Munden Parva,
Hertfordshire
SG12 0PD

Design & Access Statement
November 2023

Existing second floor plan, area of previous alterations circled

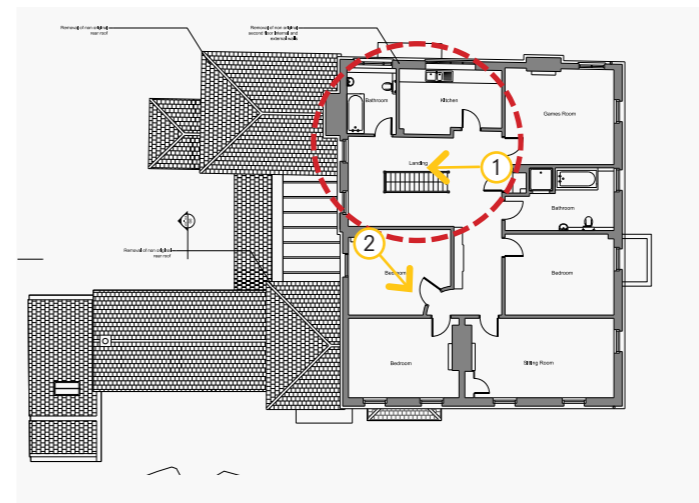
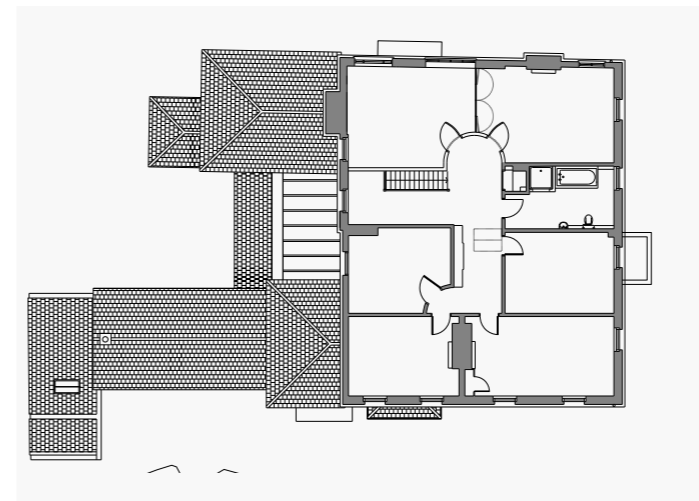
The removal of a whole floor and the roof of the listed building is a major intervention which would result in the loss of 19th century fabric which contributes towards the significance of the building. There is no photographic evidence of the exact design of the original building and therefore the proposed plans risk reinstating an inaccurate design. There are also concerns that the removal of the second floor and roof could risk damage to the original parts of the building. Overall, the removal of the second floor would result in harm to the listed building. The level of harm is considered to be substantial, and the proposal is therefore not acceptable. If the applicant wishes to continue to progress the proposals, then pre-application discussions should be undertaken with Historic England.

In response to pre-application feedback, the second floor will be retained, and its historic pre-1926 layout reinstated.
